# CITY OF ALBUQUERQUE

RE: **Lot 26 Block 1, Volcano Cliffs, Unit 22, SAD 228**  
**8005 Canoncito NW**  
**Grading and Drainage Plan**  
**Engineers Stamp Date 8/14/19 (D10D003N26)**

## DRAINAGE AND TRANSPORTATION INFORMATION SHEET (REV 6/2018)

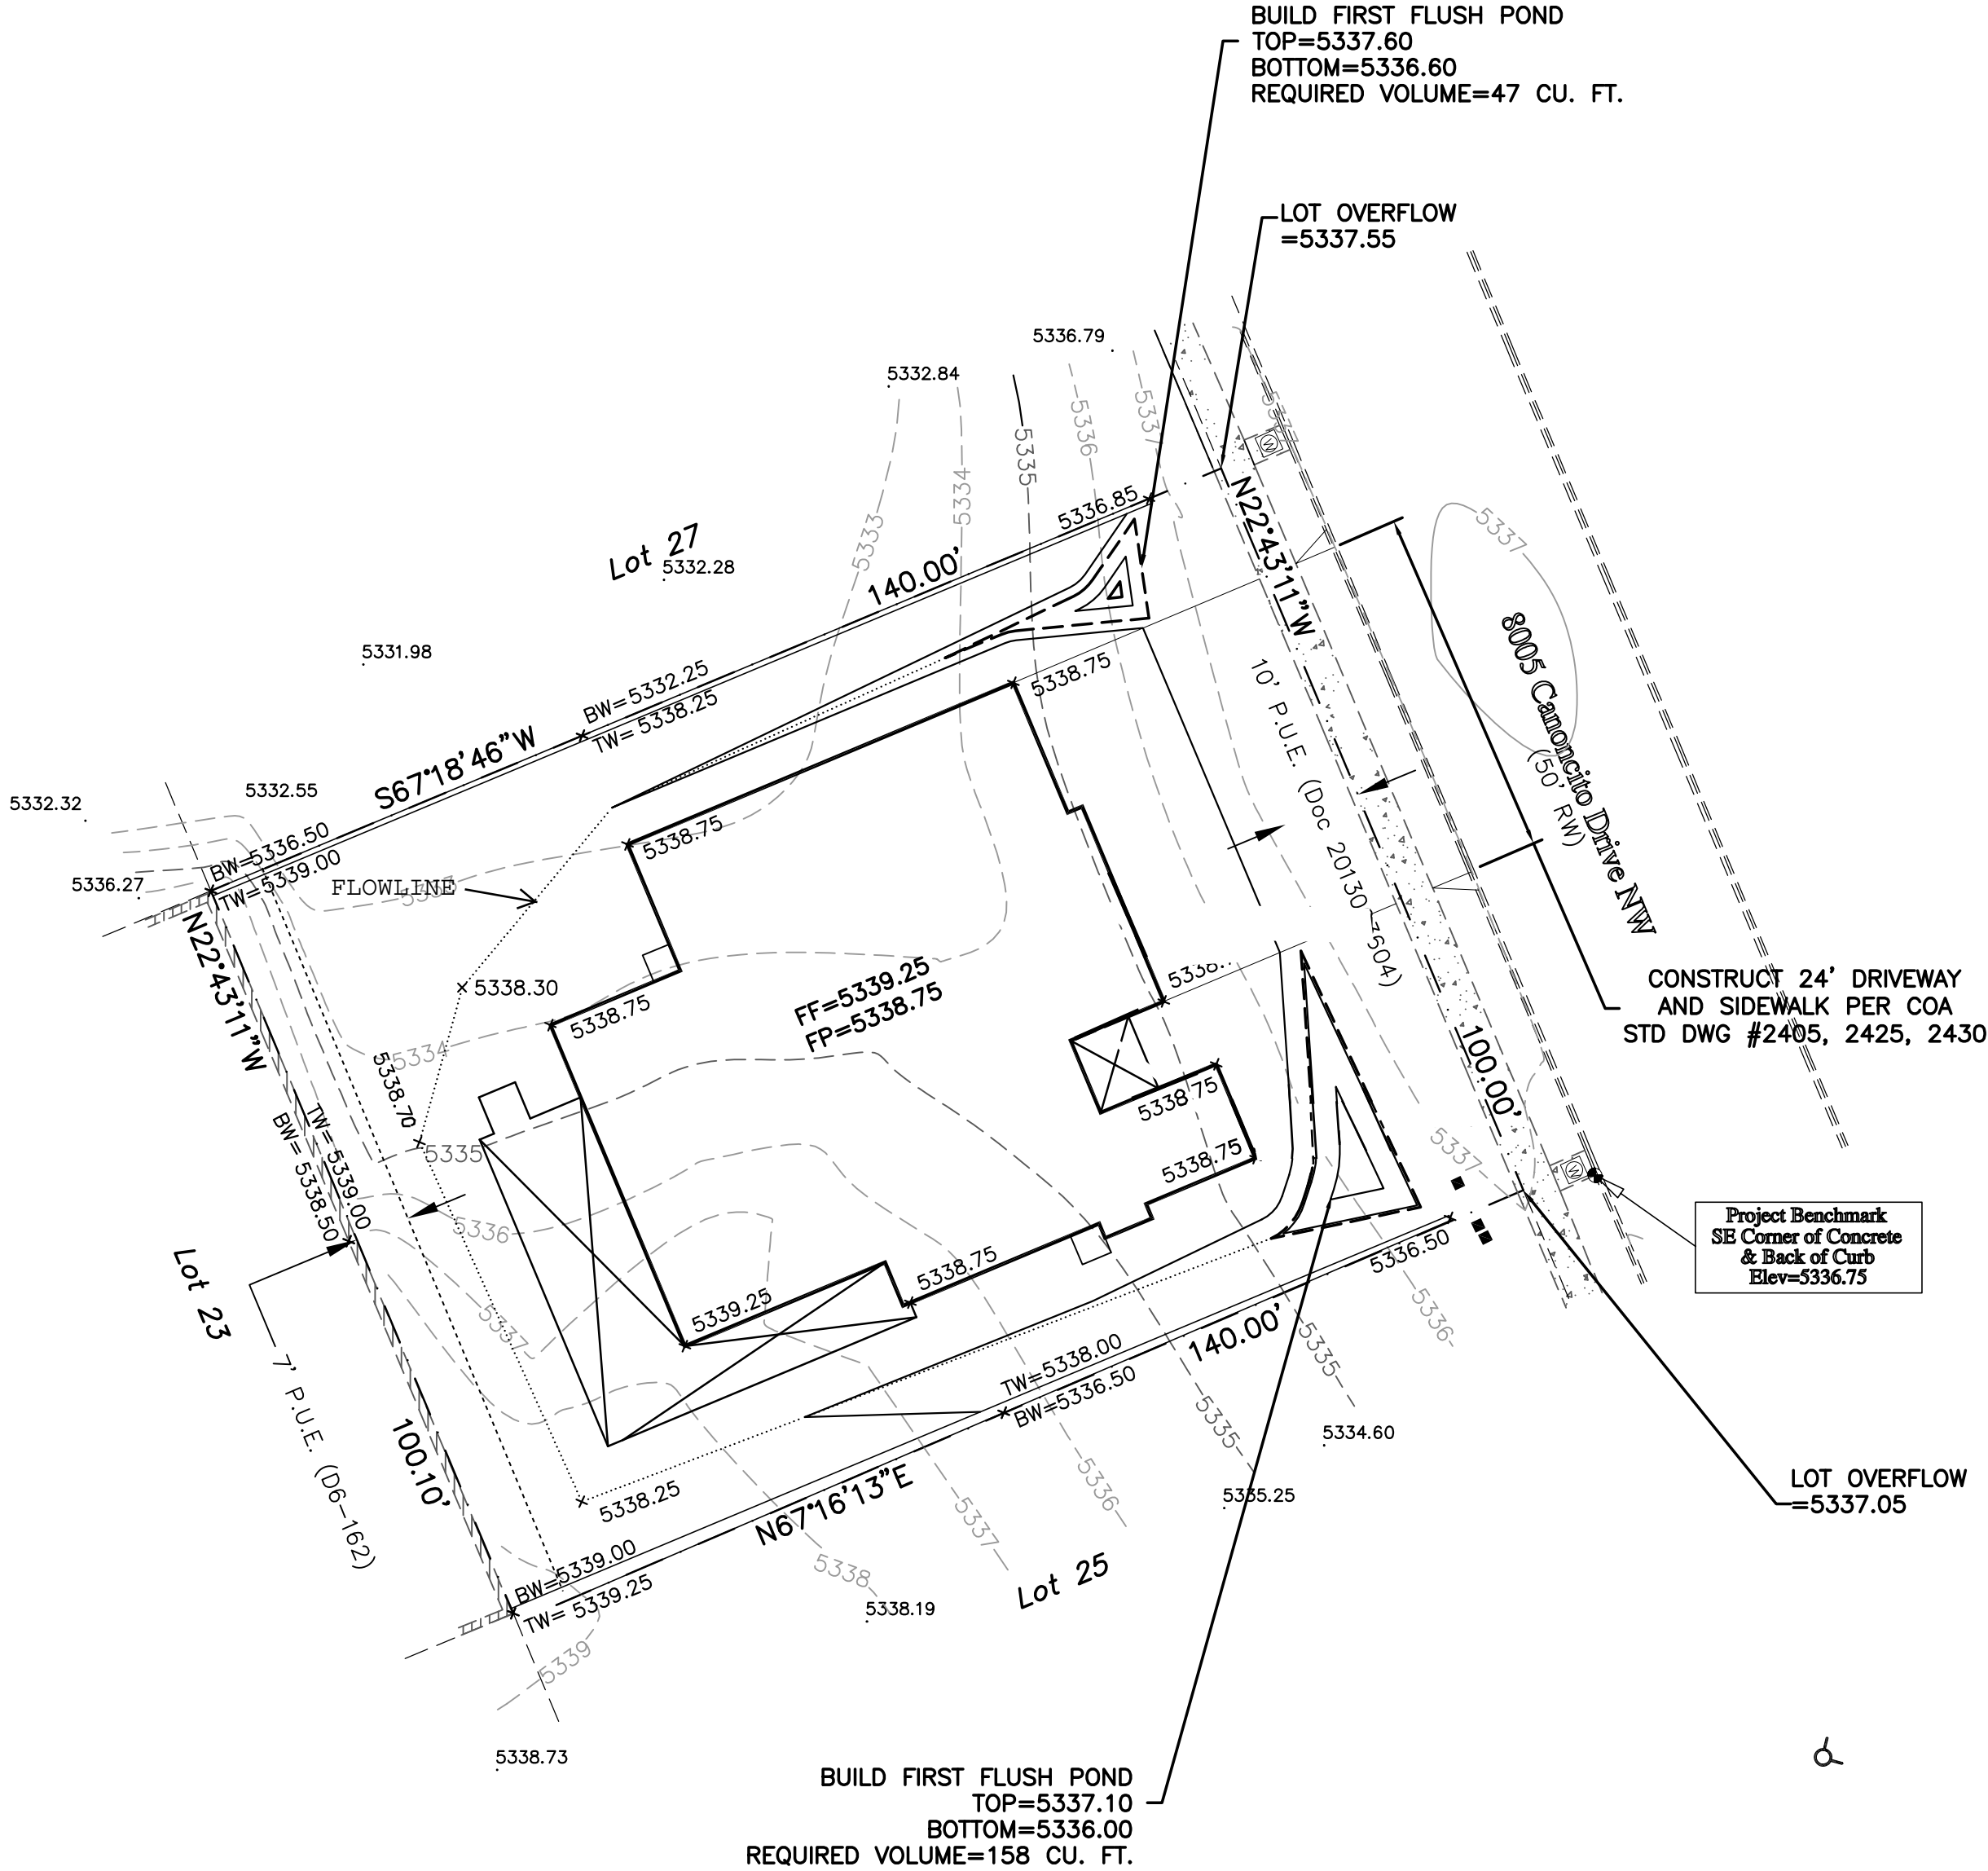
Based upon the information provided in your submittal received 8/14/19, this plan is approved for Grading Permit.

**Prior to Building permit approval a Pad Certification will be required, provided by the Engineer or a registered Land Surveyor.**

Reiterate to the Owner/Contractor that a separate permit for a garden/retaining wall must be obtained with the approved G&D plan and Pad Certification.

**Prior to Certificate of Occupancy release, Engineer Certification per the DPM checklist is required.**
